NEWS

NO. 0179
JUNE, 21, 2013

SANKEI INDUSTRY CO., LTD.
305 Takano, Ritto, Shiga, 520-3045, JAPAN
E-mail : info@sankei-555.co.jp

Product Information①

SC-5280 will be changed as follows.

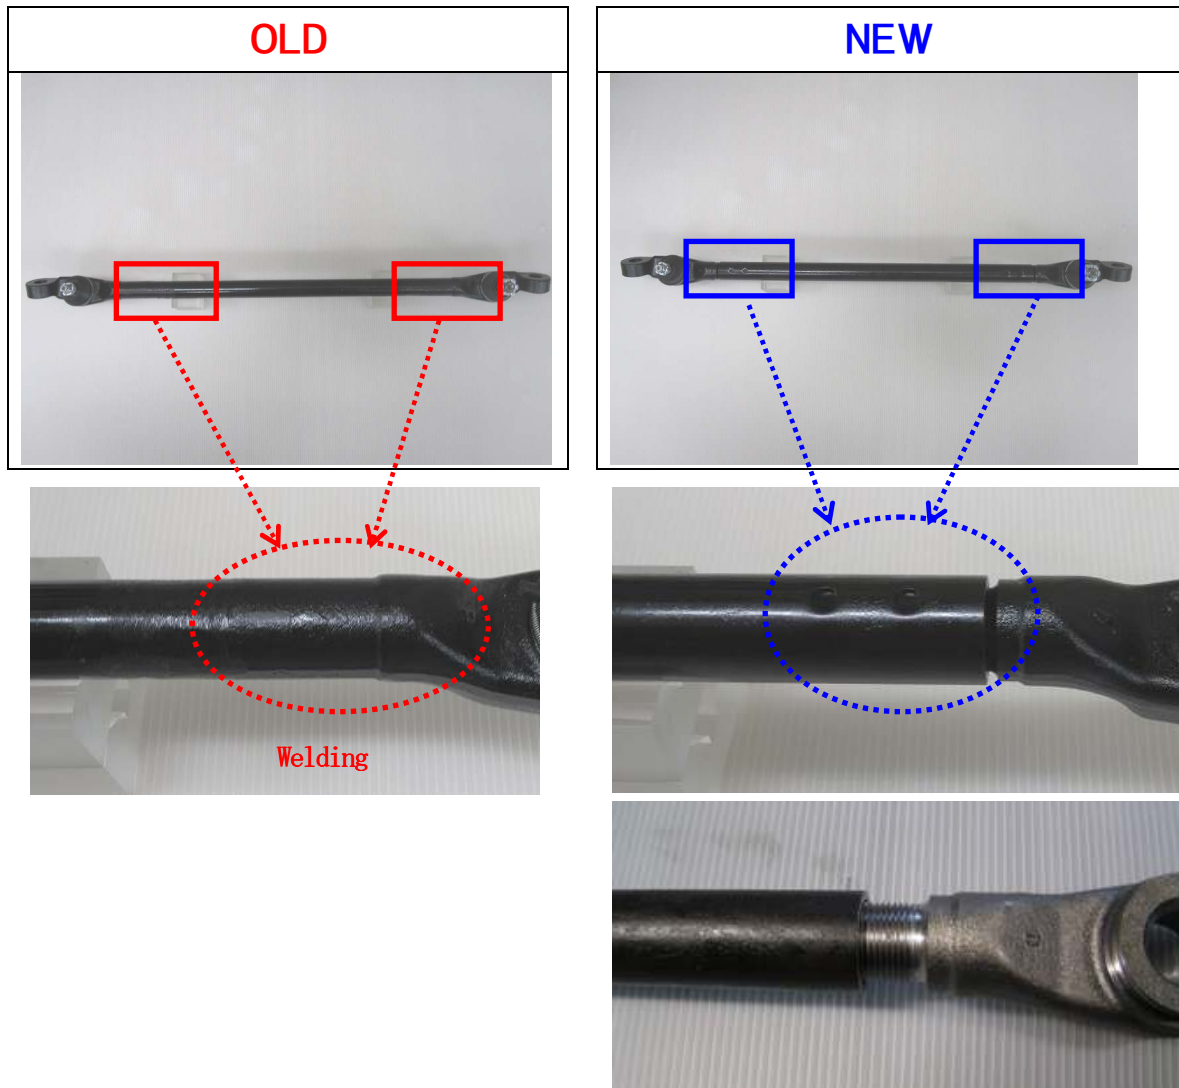
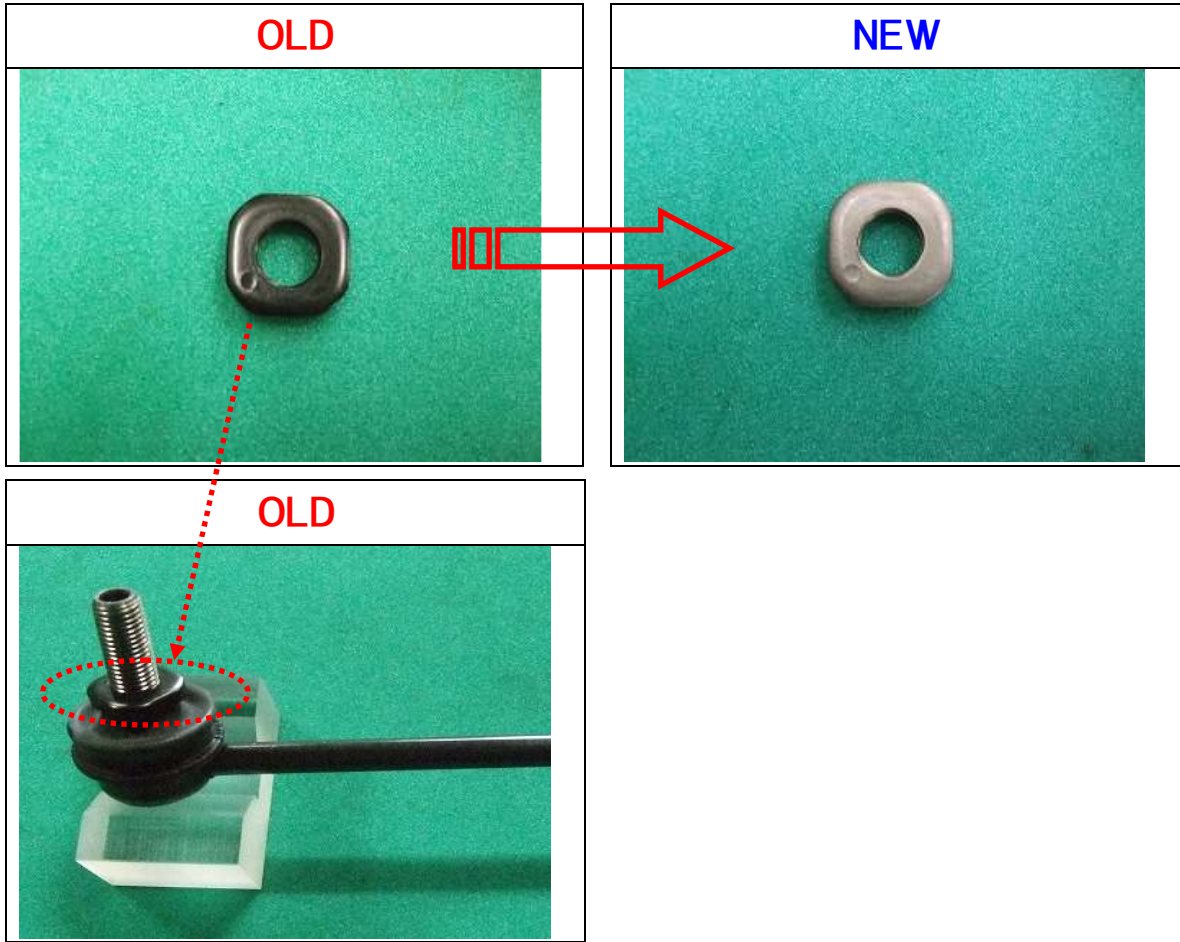
Sleeve(Tube) is joined to Socket tightly with screws and punches.

Center Shaft has been changed from Steel Bar to Steel Tube being fixed to Socket firmly by screws/punches, keeping the strength of Center Shaft.

- ①reducing the weight by 500g for Eco-Friendly Car.
- ②reducing a large amount of CO2 emissions in the welding-free process.

※The new Center Link has the same durability as O.E.M products, and also our new design with ① & ② will contribute to the global green movement.

※The new shipment starts from June 18, 2013.
